EXHIBIT D

THE BELVEDERE
NEW MULTIFAMILY DEVELOPMENT
24254 W 111TH ST
NAPERVILLE, IL 60564
JUNE 29, 2022

PROJECT NUMBER | 921084

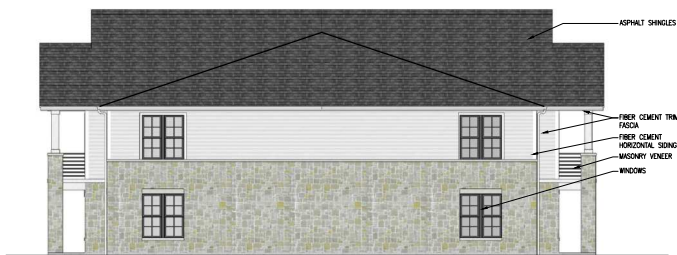
- 1 VARYING ACCENTS
1a. STONE EXTENDED FULL HEIGHT
- 2 DIFFERENT SHAPE & SIZE WINDOWS
2a. NEW WINDOWS IN A DIFFERENT SHAPE & SIZE ADDED TO EACH SIDE OF PATIO DOORS
2b. LARGER PATIO DOOR UNIT PROVIDED
- 3 DIFFERENT PORCH DESIGN
PATIO DOOR CHANGED, CABLE DESIGN DETAILS CHANGED & CABLE WINDOW ADDED TO VARY PORCH DESIGN
- 4 DIFFERENT GARAGE DOOR DESIGNS
4a. GARAGE DOOR COLOR & STYLE CHANGED
4b. METAL ROOF DETAIL ADDED OVER GARAGES
- 5 VARIED ROOF LINES
LARGE GABLE REMOVED TO VARY ROOF LINES
- 6 DORMERS
DORMERS ADDED ON MAIN ROOF

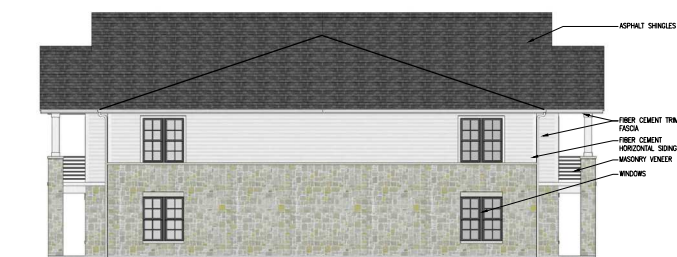
- [1] VARYING ACCENTS**
1a. SIDING & TRIM COLOR CHANGE. WOOD MATERIAL ACCENT ADDED
1b. STONE EXTENDED FULL HEIGHT
- [2] DIFFERENT SHAPE & SIZE WINDOWS**
2a. NEW WINDOWS IN A DIFFERENT SHAPE & SIZE ADDED TO EACH SIDE OF PATIO DOORS
2b. LARGER PATIO DOOR UNIT PROVIDED
- [3] DIFFERENT PORCH DESIGN**
PATIO DOOR CHANGED, GABLE DESIGN DETAILS CHANGED, GABLE WINDOW ADDED, COLORS AND MATERIALS CHANGED TO VARY PORCH DESIGN
- [4] DIFFERENT GARAGE DOOR DESIGNS**
4a. GARAGE DOOR COLOR & STYLE CHANGED
4b. METAL ROOF DETAIL ADDED OVER GARAGES
- [5] VARIOUS ROOF LINES**
LARGE GABLE REMOVED TO VARY ROOF LINES
- [6] DORMERS**
DORMERS ADDED ON MAIN ROOF

18 UNIT BUILDING - TYPE 'C'
LEFT ELEVATION
1/8" = 1'-0"

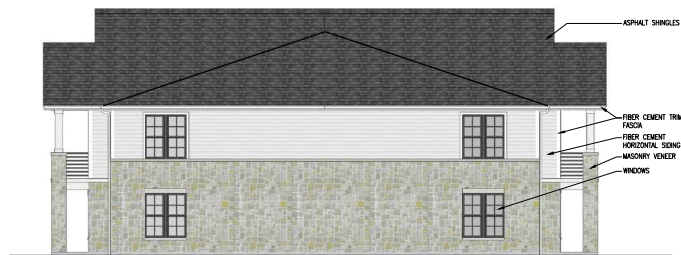
- 1 VARYING ACCENTS
1b. STONE EXTENDED FULL HEIGHT
- 2 DIFFERENT SHAPE & SIZE WINDOWS
2a. NEW WINDOWS IN A DIFFERENT SHAPE & SIZE ADDED TO EACH SIDE OF PATIO DOORS
2b. LARGER PATIO DOOR UNIT PROVIDED
- 3 DIFFERENT PORCH DESIGN
PATIO DOOR CHANGED, GABLE DESIGN DETAILS CHANGED & GABLE WINDOW ADDED TO VARY PORCH DESIGN
- 4 DIFFERENT GARAGE DOOR DESIGNS
GARAGE DOOR COLOR & STYLE CHANGED
- 5 VARIED ROOF LINES
LARGE GABLE REMOVED TO VARY ROOF LINES
- 6 DORMERS
DORMERS ADDED ON MAIN ROOF
